Minutes of the State Appeals Board
Appeal #15-03
Tuesday, May 19, 2015
Hearing @ 9:15 a.m.

RE: Single Family Dwelling
3401 Lakeridge Place NW
Plan #15-227
PERMIT #: R15-0159RB

PLAN VIEW

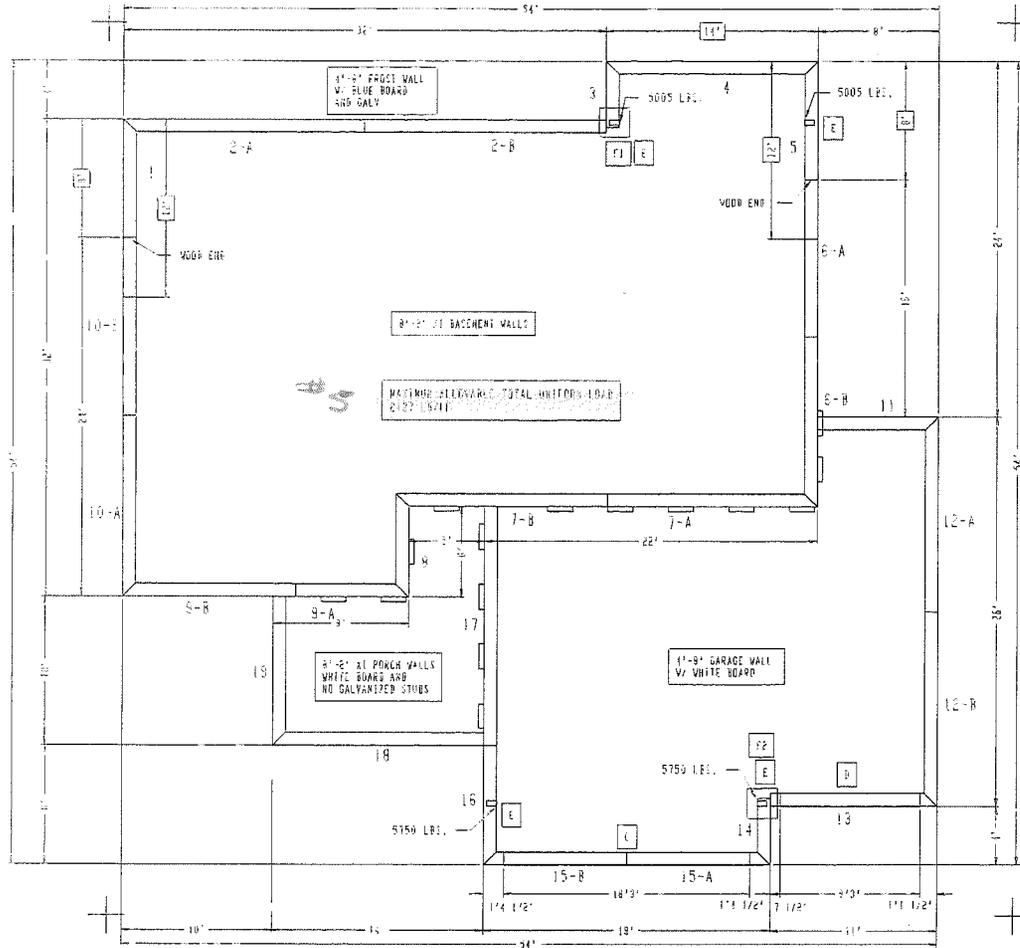
All 7 items noted above are listed on CAD drawings submitted and he referred to page 1 and 3 on Superior Walls drawing sheets (**see Attachment B**). Palmer referred to MN Statute 326B.03 LICENSE OR CERTIFICATE REQUIRED, Subd. 2 Exceptions (for single family homes), item (1) noting the only item that would need this would be for special conditions. This is not a special condition; this is the foundation that meets the building code.

- Randy Johnson, Building Official, City of Rochester, said it has been their interpretation that precast foundation walls require engineering. He noted that the application for this individual home came in prior to the code change so technically they are under the 2007 Minnesota State Building Code; therefore, they are re-applying the ICC Evaluation Report. They look at condition 5.5 which indicates that design calculations in drawings need to be submitted to the building official for review. This is what the correction letter (**see Attachment A**) indicated. Since that time they have had numerous run-ins with the applicant wanting to use the 2015 Minnesota State Building Code which has provisions for dealing with precast concrete foundation walls. His final determination is based on the fact that the applicant references the 2015 Minnesota State Code and he believes that IRC section 404.5 indicates that precast concrete foundation walls shall be designed in accordance with accepted engineering practices and that the drawings shall be submitted to the building official for approval prior to the installation. They are trying to get the drawings for this precast concrete foundation system. He referred to Superior Walls isometric drawings (**see Attachment D**) and said these drawings show minimal information regarding the construction of the walls and because it is a precast wall system they are asking for the drawings that show construction of the wall, not for details of the gravel footings or the attachment of the joist; however, this is what they keep providing. How are the walls designed? This is the question they keep asking. They have an Evaluation Report that says there are certain size studs at 24 inches on center and they believe the face shell thickness is 1-3/4 inches but this should be indicated on the drawings as to how it is going to be constructed. If there is some type of design program behind the CAD program that could verify design loads to the foundation system it has not yet been provided. The resubmitted drawings indicate the same isometric drawings but also included a number of tables that appears to be a copy from their builder's guideline book. They are general in nature and do not provide specific information regarding the

construction of the foundation wall system. There appears to be an absence of a designer with regard to the design of the system. With regard to the contention of the statute, they do not have a statute requiring certification by a structural engineer. His argument with this is if the City of Rochester doesn't have statutes that require registered design professionals for residential projects then every building official in the state of Minnesota is in violation because every jurisdiction requires certified engineered trust drawings. This is an engineered component. They require those to be signed and certified by an engineer every time because it is an engineered design system. The applicant and Mr. Palmer state this is a pre-engineered system and if it's a pre-engineered system then where is the engineering. He has requested calculations but has not received any.

A motion was made by Kelsey, seconded by Nord, that the building official has the authority to require additional information and/or certification by the licensed design professional. The vote was unanimous; the motion carried.
